SUNDRY NOTICES AND REPORTS ON WELLS (DO NOT USE THIS FORM FOR PROPOSALS TO DRILL OR TO DEEPEN OR PLUG BACK TO A DIFFERENT RESERVOIR. USE "APPLICATION FOR PERMIT" (FORM 100) FOR SUCH PROPOSALS.)		WELL API NO. <b>30-015-27619</b>

2. Name of Operator <b>COG Operating LLC</b>		6. State Oil & Gas Lease No. <b>647</b>
3. Address of Operator <b>600 W. Illinois, Midland, TX 79701</b>		7. Lease Name or Unit Agreement Name <b>Arco 26 A State</b>

<b>NOTICE OF INTENTION TO:</b> PERFORM REMEDIAL WORK <input type="checkbox"/> PLUG AND ABANDON <input checked="" type="checkbox"/> TEMPORARILY ABANDON <input type="checkbox"/> CHANGE PLANS <input type="checkbox"/> PULL OR ALTER CASING <input type="checkbox"/> MULTIPLE COMPL <input type="checkbox"/> DOWNHOLE COMMINGLE <input type="checkbox"/>		<b>SUBSEQUENT REPORT OF:</b> REMEDIAL WORK <input type="checkbox"/> ALTERING CASING <input type="checkbox"/> COMMENCE DRILLING OPNS. <input type="checkbox"/> P AND A <input type="checkbox"/> CASING/CEMENT JOB <input type="checkbox"/>	
OTHER: <input type="checkbox"/>		OTHER: <input type="checkbox"/>

CURRENT WELLBORE DIAGRAM

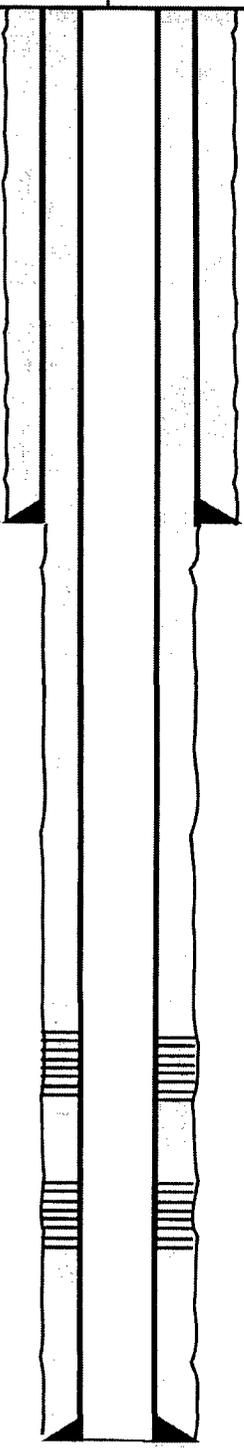
ADD A QUEEN PLUG @ 1350' - 25 SKS - WOC & TAG  
 SPOT @ 100' - @ IRC TO SURF

← SPOT @ 100' - CIRC TO SURF

← PERF & SQ @ 596' - WOC & TAG

← ADD A QUEEN PLUR  
SPOT @ 1350' - 25 SXS - WOC & TAG
